**Planning Board Meeting Agenda
Brunswick Town Hall
85 Union Street – Council Chambers
Tuesday, February 10, 2026 @ 6:00 PM**

4. **Case No. 25-059 – MaineHealth Mid Coast Cancer Center Renovation:** The Planning Board will review and act upon a **Site Plan Amendment** application submitted by Pine Tree Engineering on behalf of the property owner, Mid

DRAFT FINDINGS OF FACT SKETCH PLAN MAJOR DEVELOPMENT REVIEW PLANNING BOARD

SHEET TITLE AND NUMBER:
AS1.00

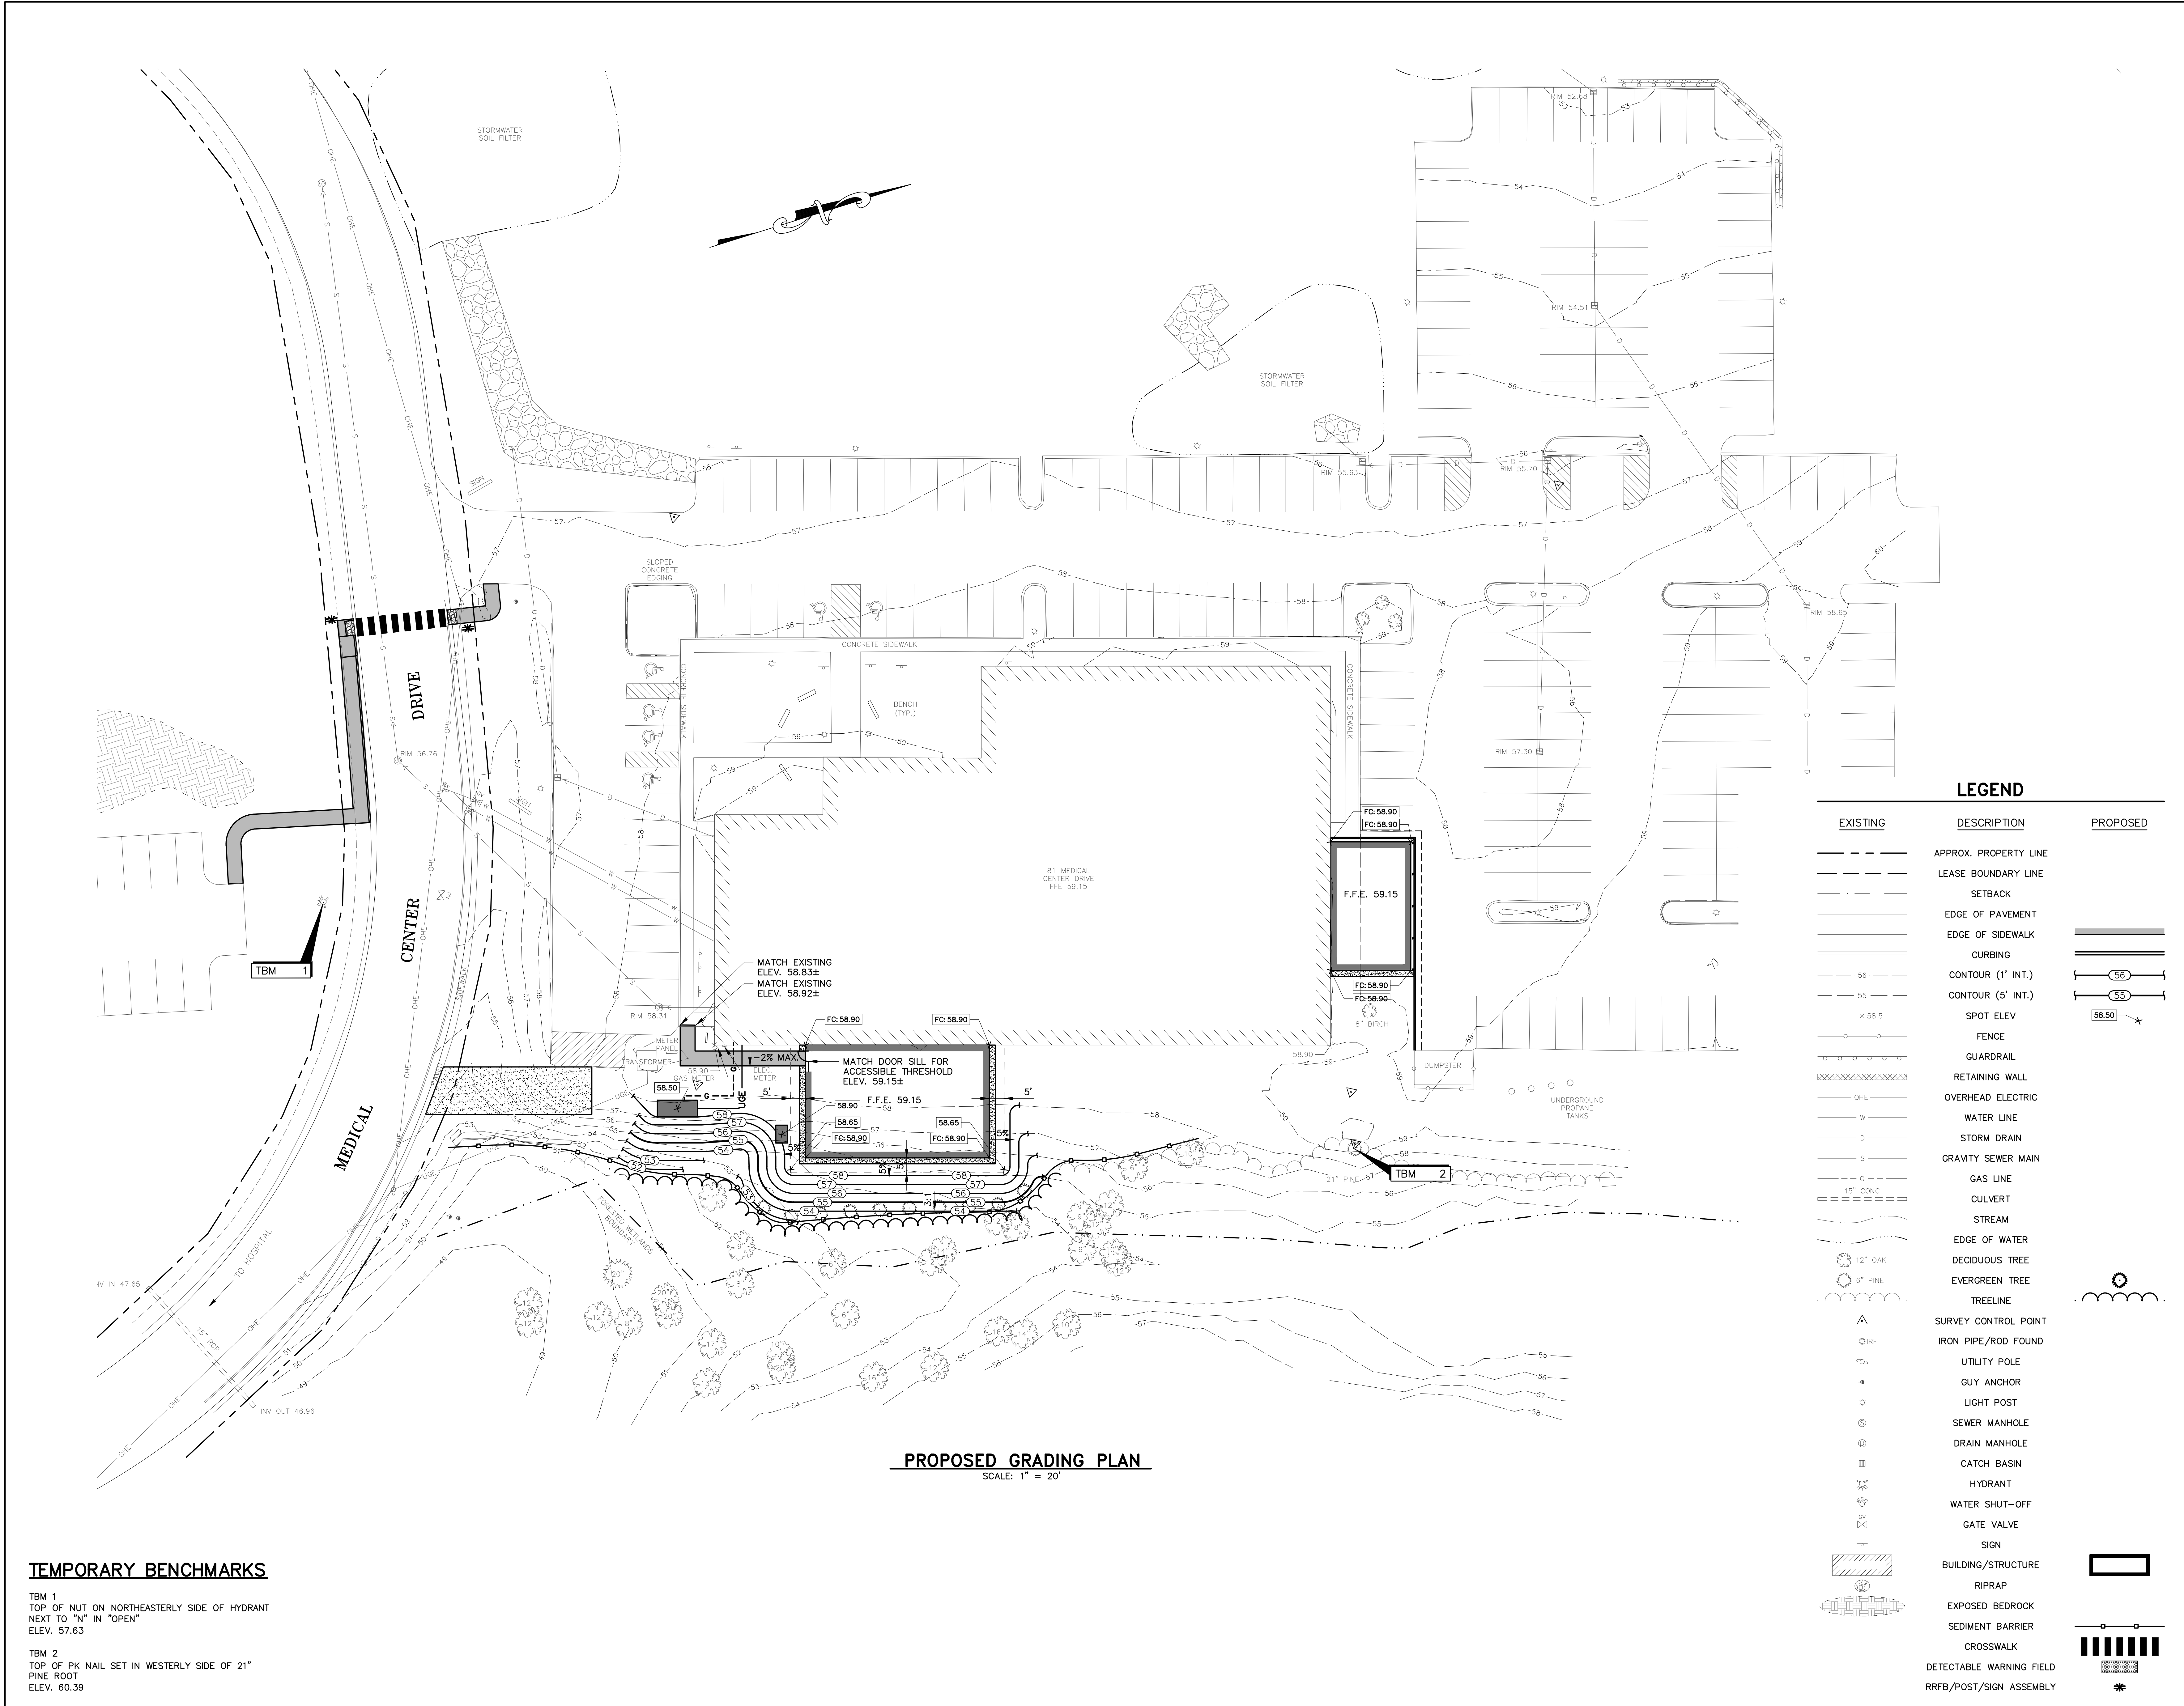
Landscaping Comments	Applicant Response
1. Add 10 evergreen trees at 10' o.c. spacing along proposed treelines	The proposed trees have been added to AS1.00 Proposed Site Plan.

6. Add Erosion Control Barrier linework to plans	Linework for the temporary sediment barrier has been added to AS1.00 Proposed Site Plan.
7. Add bicycle rack locations and callouts to plan (min. 13 spaces)	The proposed bicycle rack has been added to AS1.00 Proposed

Site Plan.
8. Add callouts for sediment sack to inlets	A callout for Temporary inlet protection has been added to AS1.00 Proposed Site Plan
General Comments
